10.3 Main Steam Supply System

The information in this subsection of the reference ABWR DCD, including all subsections, tables, and figures, is incorporated by reference with the following departures and supplements.

Figure 10.3-1 Main Steam Supply System

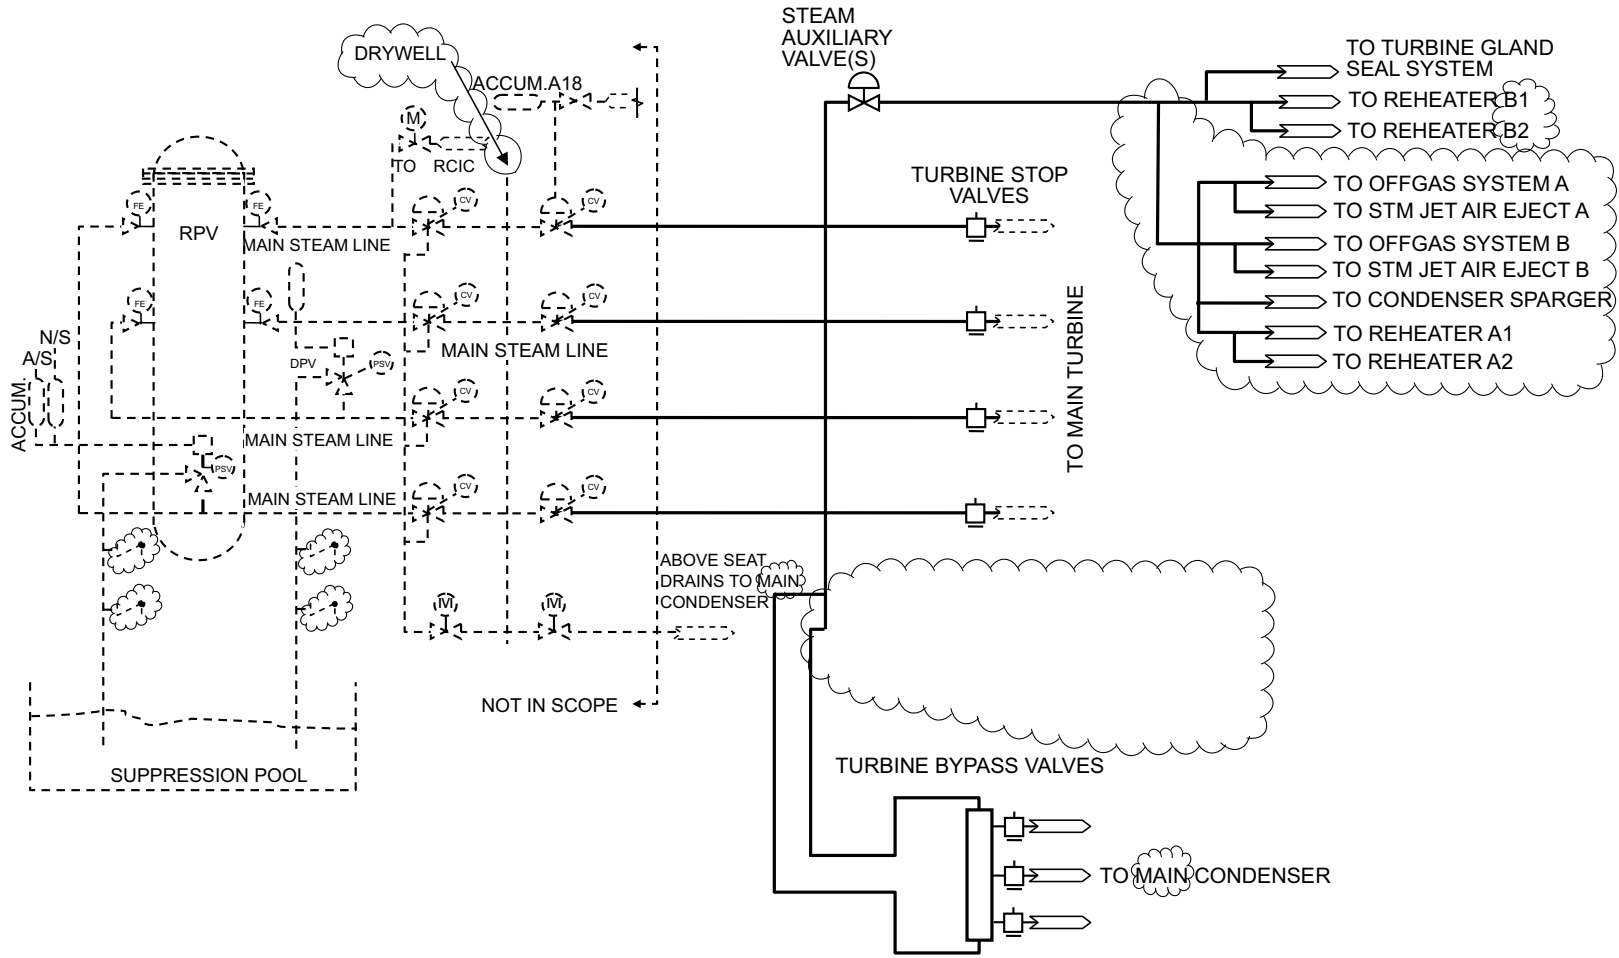
STP DEP 10.2-1 ([Table 10.3-1](#), Figures 10.3-1 and 10.3-2)

The Main Steam Supply System is illustrated in Figure 10.3-1. The system design data is provided in Table 10.3-1. The main steam piping consists of four 700A pipe size diameter lines from the outboard MSIVs to the main turbine stop valves. The four main steamlines are connected to a header upstream of the turbine stop valves to permit testing of these valves ~~the MSIVs~~ during plant operation with a minimum load reduction. This header arrangement is also provided to ensure that the turbine bypass and other main steam supplies are connected to operating steamlines and not to idle lines. The main steam process downstream of the turbine stop valves is illustrated in Figure 10.3-2.

The drains from the steamlines inside containment are connected to the steamlines outside the containment to permit equalizing pressure across the MSIVs during startup and following a steamline isolation.

~~A drain line is~~ Drain lines are connected to the low points of each main steamline, both inside and outside the containment. Both sets of drains are headered and connected with isolation valves to allow drainage to the main condenser. To permit intermittent draining of the steamline low points at low loads, orificed lines are provided around the final valve to the main condenser. The steamline drains, ~~except including the drains through the Control Building, maintain a continuous downward slope from the steam system low points to the orifice located near the condenser~~ in the direction of flow to the steam system line drain low points in the Reactor Building steam tunnel and then slope upward to reach the high point in the steam tunnel above the Control Building. From this high point in the Control Building, the lines slope downward in the direction of flow to the Nuclear Island-Balance of Plant piping interface one meter outside of the Control Building. Although the drain lines flow upward for a portion of their travel, the differential pressure between the condenser and main steam lines, combined with the bypass and orifice isolation valves in the drain lines, which are controlled by reactor pressure and power, respectively, ensure complete drainage while preventing water hammer. To permit emptying the drain lines for maintenance, drains are provided from the line low points going to the radwaste system.

Figure 10.3-2 Main Steam Turbine System

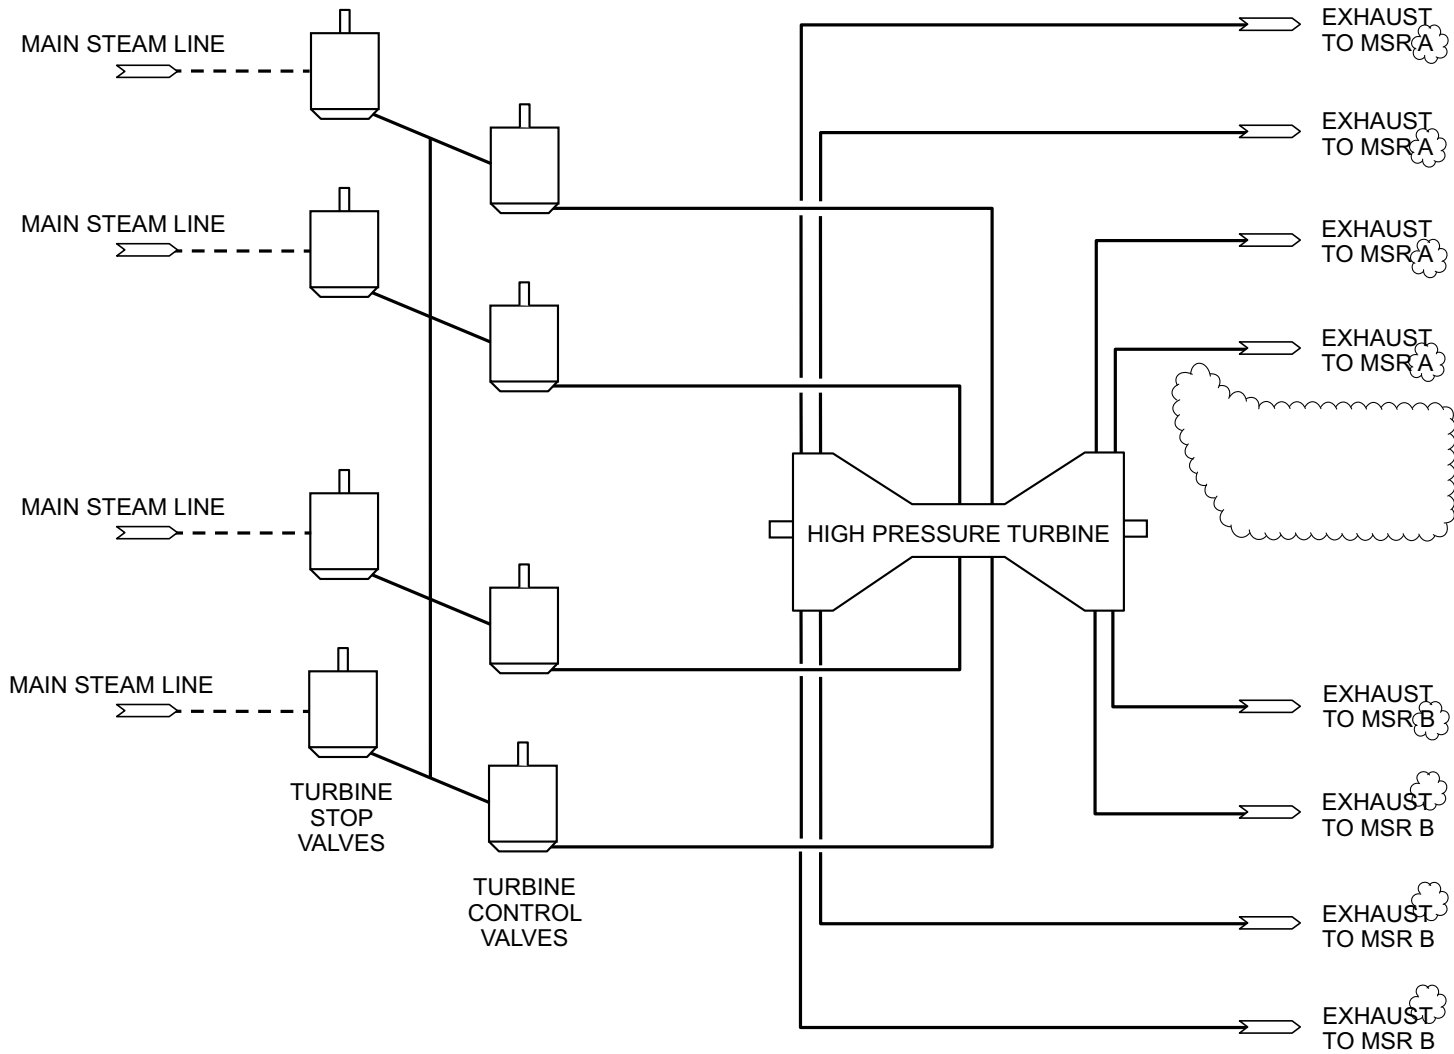
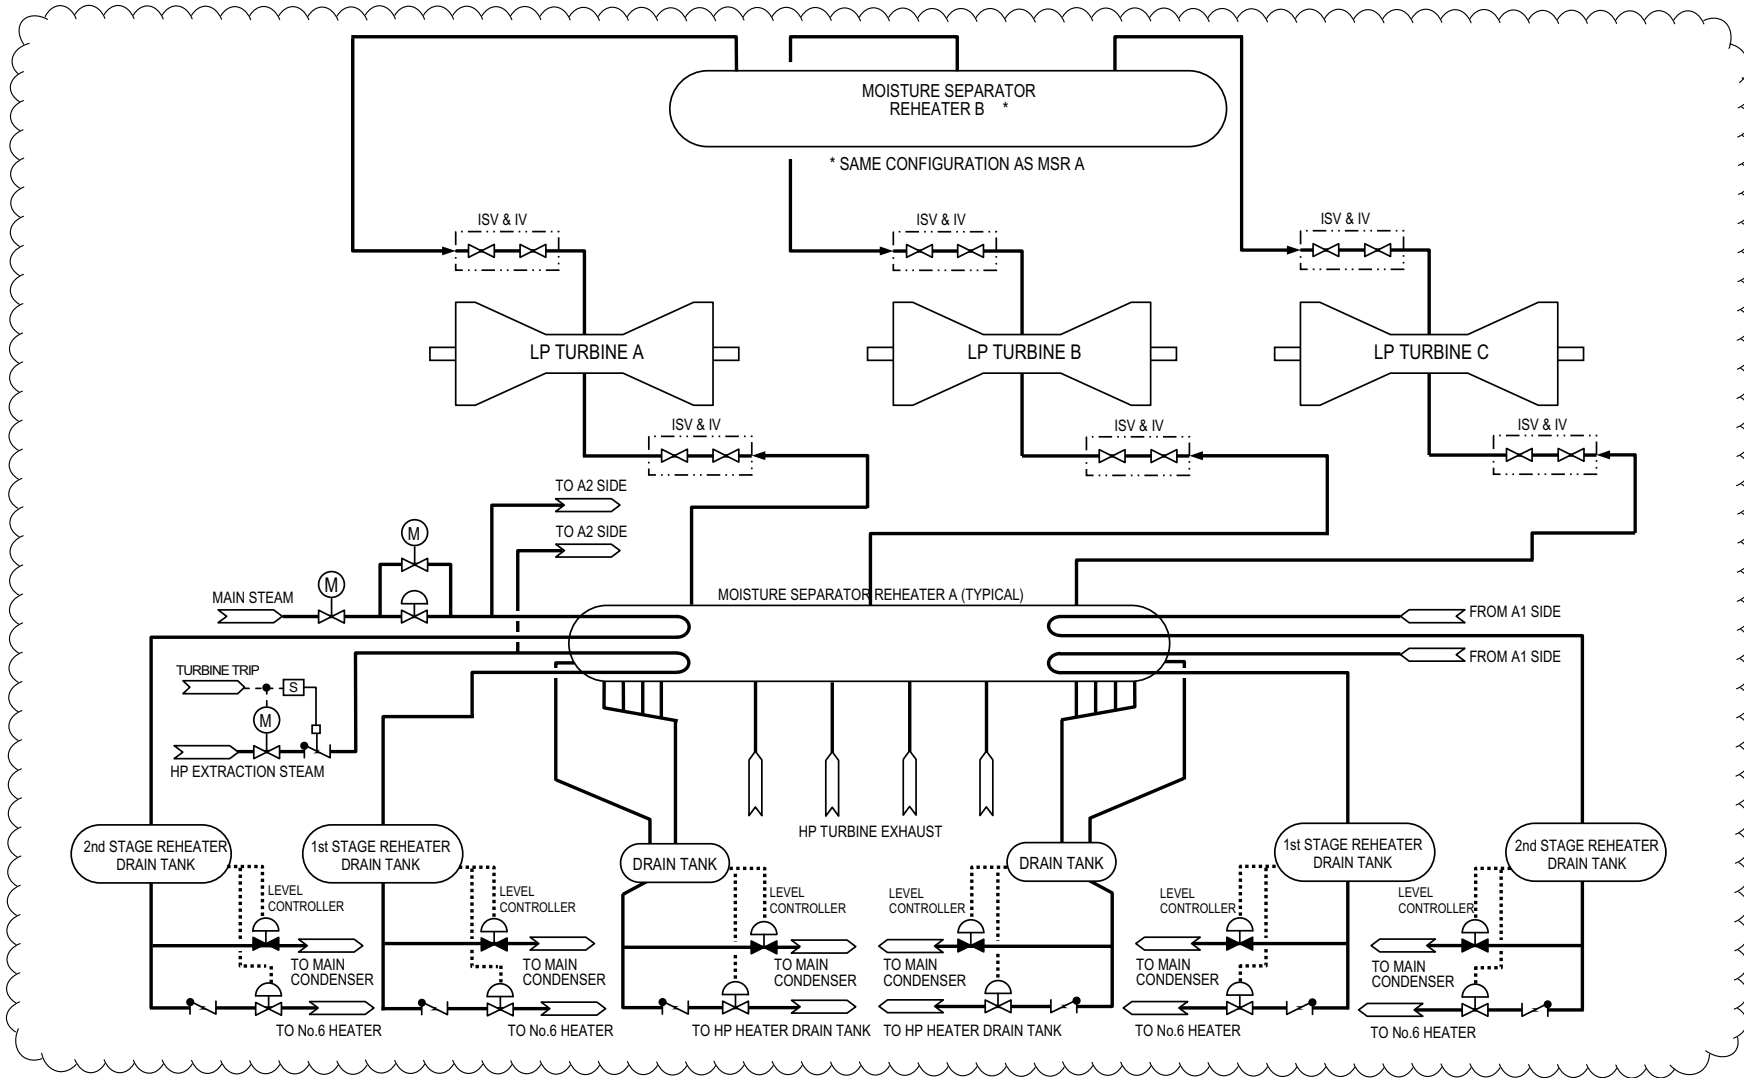
STP DEP 10.4-3 (Figure 10.3-2)

~~Normal Operation — At low plant power levels, the Main Steam System may be used to supply steam to the turbine gland steam seal system. At high plant power levels, turbine gland sealing steam is normally supplied from the high pressure heater drain tank or related turbine extraction.~~ During startup, the turbine gland seal steam system is supplied from the auxiliary boiler. At a sufficient pressure during reactor startup and up to rated power operation, seal steam is supplied by the gland steam evaporator. The source of heating steam for the evaporator is main steam or turbine extraction steam.
